AGENDA ITEM 5

APPENDIX 6

2016/0060/DET

REPRESENTATIONS

Effected Amenity of kitchen at 6 Revoan Drive

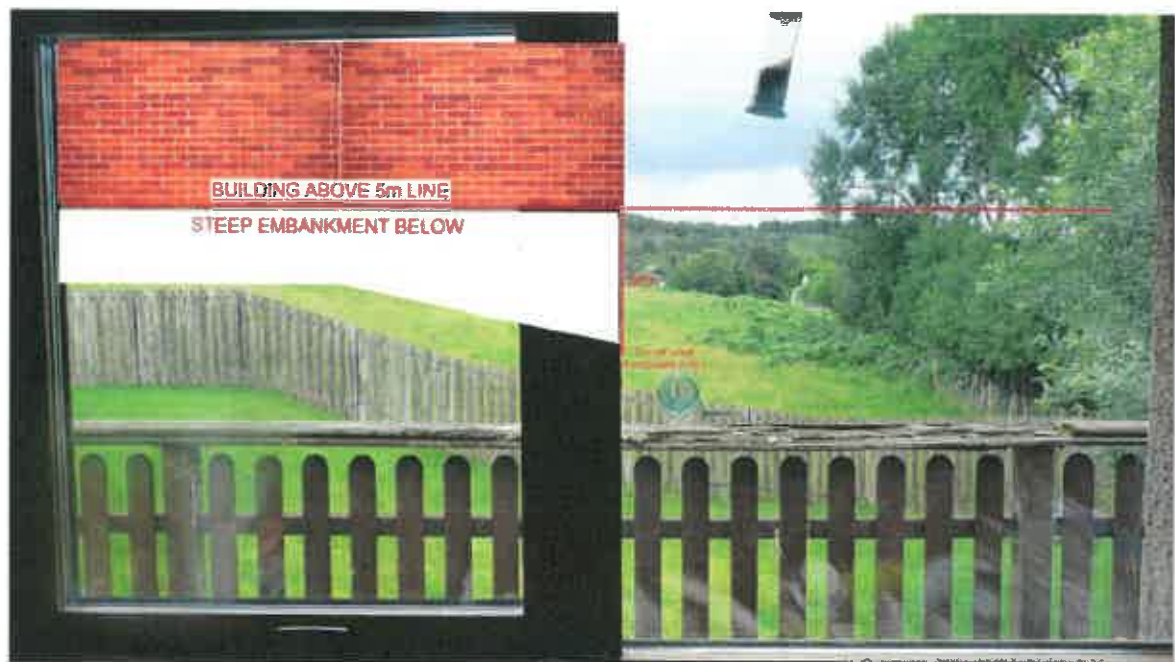
A building with a 5m elevation (at its base) will affect our privacy as residents will look directly into 3 bedroom, 2 bathroom and 1 kitchen window. The amenity and use of our garden will be adversely affected, by any new development. As the land naturally slopes upwards from our property, even a building with zero elevation would negatively affect our privacy and amenity. Similarly, the amenity of the north facing kitchen will be negatively affected by the proposed development, at such an elevation, as it will block out a substantial amount of light (see diagram below showing affected amenity of kitchen)

We have created a simulated view of what a new development, on top of a 5m elevated base might look like from our kitchen window. All measurements are to scale, and we have correctly measured out the proposed corner point of the new building.

The "Before" and "After" views need very little additional explanation to demonstrate just how much light will be blocked out, and how our view and overall amenity of our kitchen will be negatively affected. It does not make sense to plan an elevated building on this site, much less a block of flats.
